**GENERATION INTERCONNECTION
REQUEST # GI-2014-2**

**FACILITY STUDY REPORT
35 MW PV SOLAR, ALAMOSA COUNTY, COLORADO**

XCEL ENERGY – PSCO TRANSMISSION PLANNING WEST
July 22, 2016

B. Figure 3. Project General Arrangement at San Luis Valley Substation

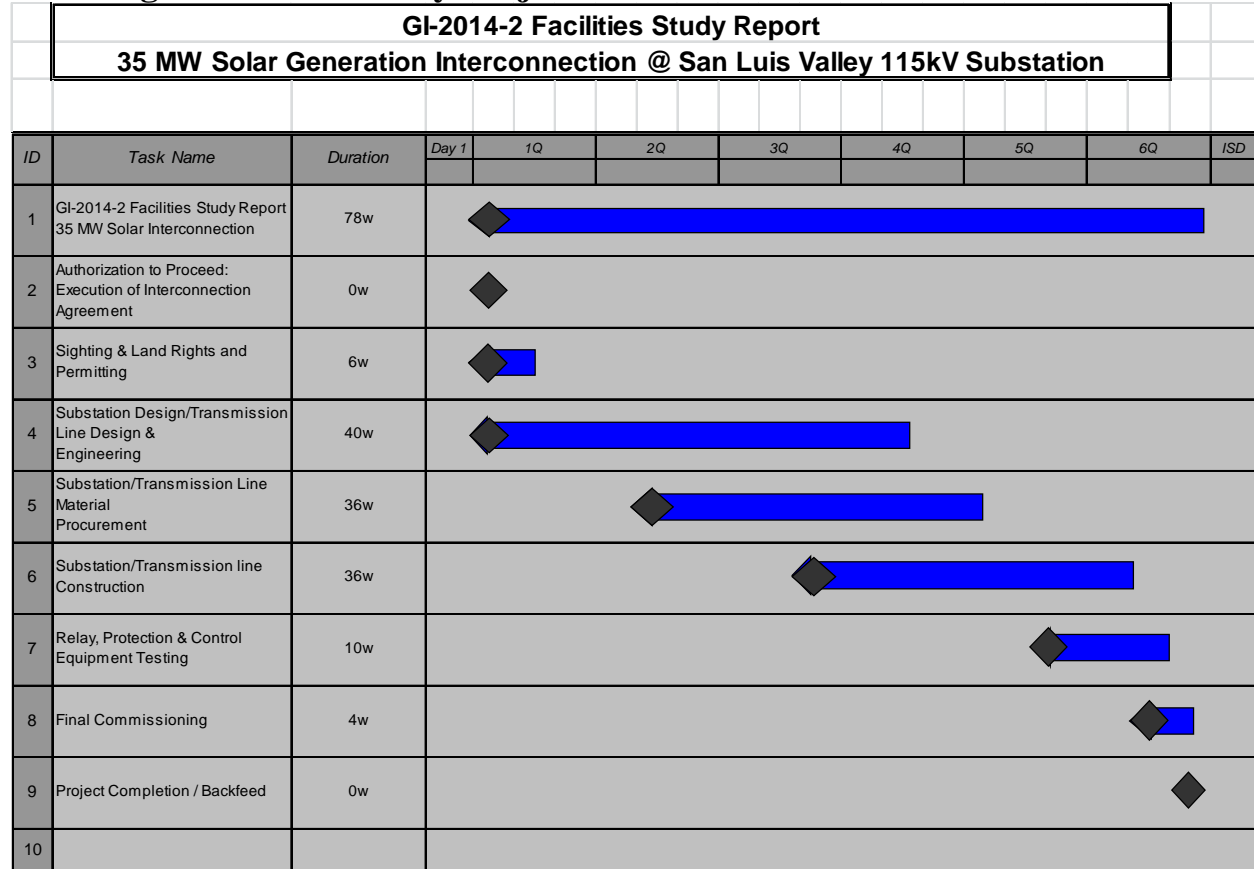
- There are plenty of 120/240VAC breakers available.
- The number of 115kV switches in Table 1 does not match the one-line.
- A comment regarding the GA: It looks like the preliminary design may compromise large vehicle access to the 230kV equipment.

- Page 8 of the document states that there is no yard expansion. Please confirm this is correct under the scenario of replacing T2 as it looks pretty tight.
